## Staff Report to the Planning Commission

Application Number: **07-0613**

**Project Description:** Proposal to construct a two story, 40 foot maximum height meditation hall of about 24,000 square feet at an existing Buddhist monastery to replace a previously demolished meditation hall, to recognize two existing cabins/huts, and to convert an existing single family dwelling to an office. Requires an Amendment to permit 92-0817.

## ACC.2

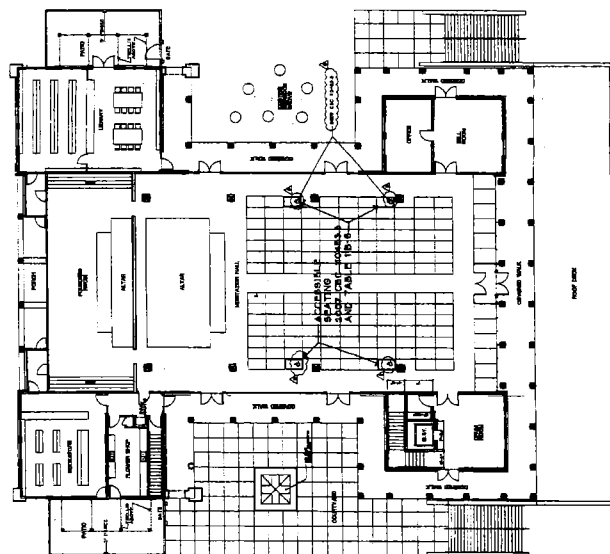
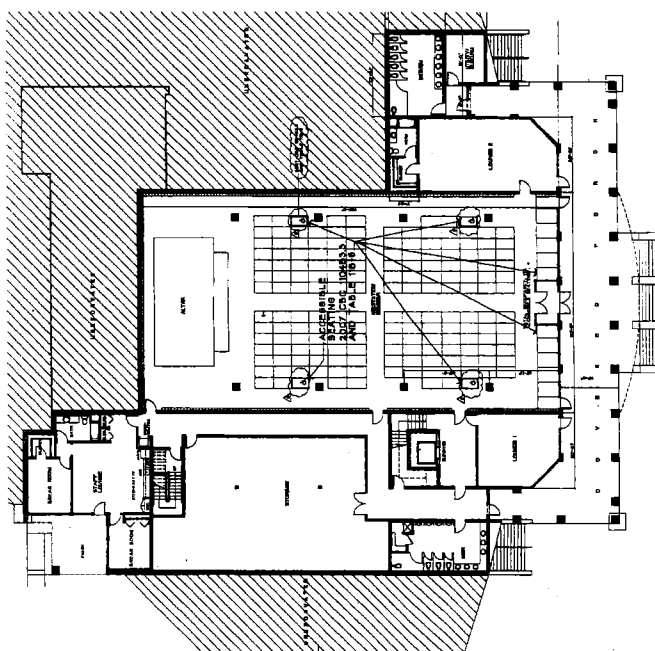
- New Sheet ACC.1: The lower deck elevation is show as 2036. The concrete walk adjacent is shown as 2037. This discrepancy is unacceptable; this is supposed to be the accessible exit from the lower level. Detail the transition from the deck to the walk. Then, over by the existing main hall, the walk is shown as 2038. Is this a mistake? Additional grading may be required.

- b. Clarification of the elevations at the lower deck of the meditation hall and at the adjacent concrete walkway at the accessible exit. Additional grading required must be shown on the grading plans.

## DRAINAGE PLAN AT NEW MEDITATION HALL

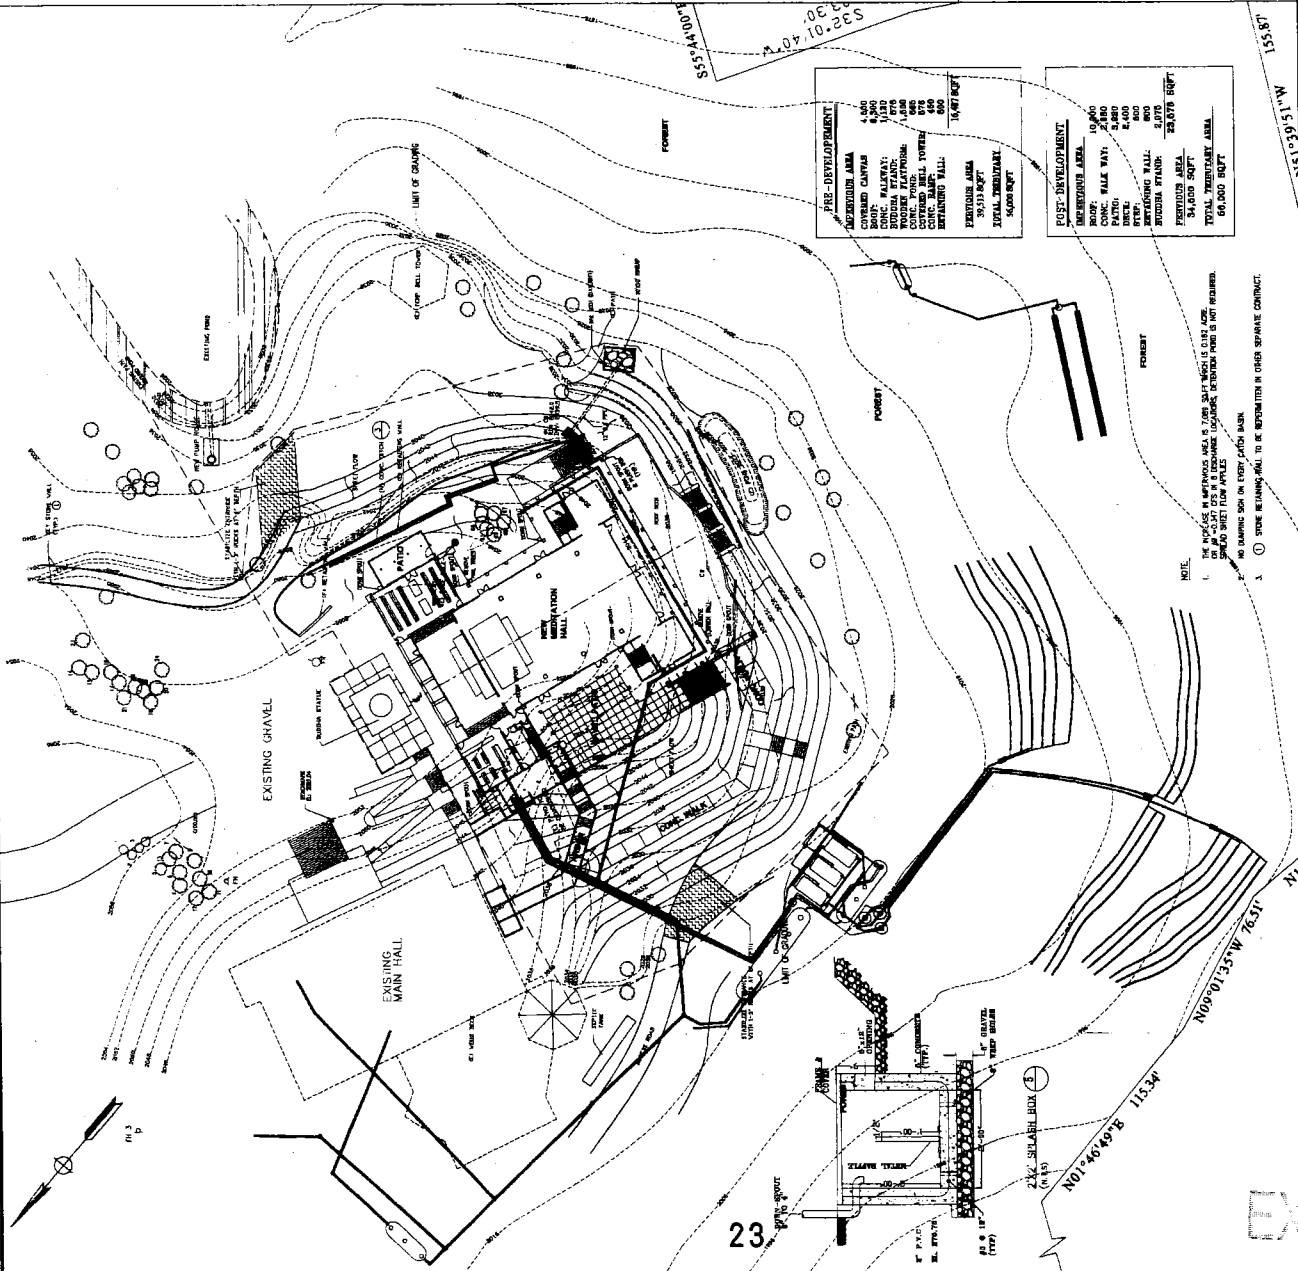
1. The plans are not clear how parking area "G" will be configured / graded. The portion of parking area "G" below the proposed Meditation Hall is not a flat area and will require extensive grading. The parking area location shown on sheet C-1 is also in conflict with the location shown on sheet C-3 in that the parking area is shown where the meditation hall will be
